Access Compliance Report

Public Rights-of-Way

Intersection ID: 3766	Main Street: OLYMPUS_DR	Cross Street: SHIMMERING_LAKE_DR	Location: W
ADA ID: E8C7527405E3	Ramp Type: BlendTrans1	Initial Pass/Fail: Fail	Overall Compliance: No
		Severity Score: 21.25

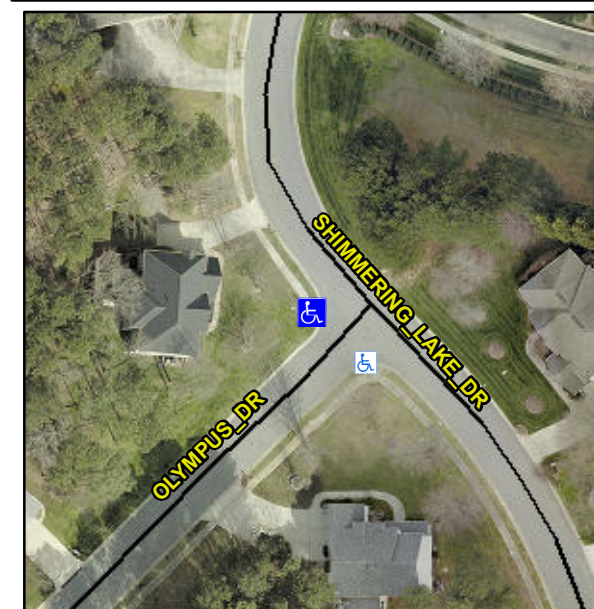
Compliance	Description	Data	Compliance	Description	Data
N/A	Ramp Length (in)	46.0	Yes	BlendTrans Slope (%)	2.6
No	Ramp Width (in)	39.0	No	BlendTrans XSlope (%)	5.6
N/A	Flare Type LT	N/A	N/A	Flare Type RT	N/A
N/A	Flare Slope LT (%)	N/A	N/A	Flare Slope RT (%)	N/A
N/A	Flare Traversable LT?	N/A	N/A	Flare Traversable RT?	N/A
N/A	Landing Length (in)	N/A	N/A	DWS Provided?	N/A
N/A	Landing Width (in)	N/A	N/A	DWS Contrast?	N/A
N/A	Landing Slope (%)	N/A	N/A	DWS Length (in)	N/A
N/A	Landing X Slope (%)	N/A	N/A	DWS Full Width?	N/A
N/A	Landing Curb? (Y/N)	N/A	N/A	DWS Offset (in)	N/A
N/A	Shared Landing?	N/A			
N/A	Gutter Ponding?	N/A	N/A	Gutter Slope (%)	N/A
N/A	Gutter Lip Ht (in)	N/A	N/A	Gutter X Slope (%)	N/A
N/A	Painted X Walk1?	No	N/A	Painted X Walk2?	N/A
	X Walk 1 Direction	To SE		X Walk 2 Direction	N/A
	X Walk 1 Width (in)	N/A		X Walk 2 Width (in)	N/A
	X Walk 1 Slope (%)	10.2		X Walk 2 Slope (%)	N/A
	X Walk 1 X Slope (%)	2.8		X Walk 2 X Slope (%)	N/A

N/A	Ramp inside XWalk1?	N/A	N/A	Ramp inside XWalk2?	N/A
	Road Slope (%)	2.8		Clear Space?	N/A
	Road X Slope (%)	10.2	N/A	Clear Space to XWalk (in)	N/A
N/A	Any Obstructions?	N/A	N/A	Storm Grate/Utility Hazard?	N/A
	Obstruction Type			Storm Grate/Utility Type	
		N/A			N/A
			Yes	Surface Condition? (G/P)	Good
			N/A	Curb Slope (%)	4.8

Remove & Replace Curb Ramp With Two New Directional Ramps or Equivalent.
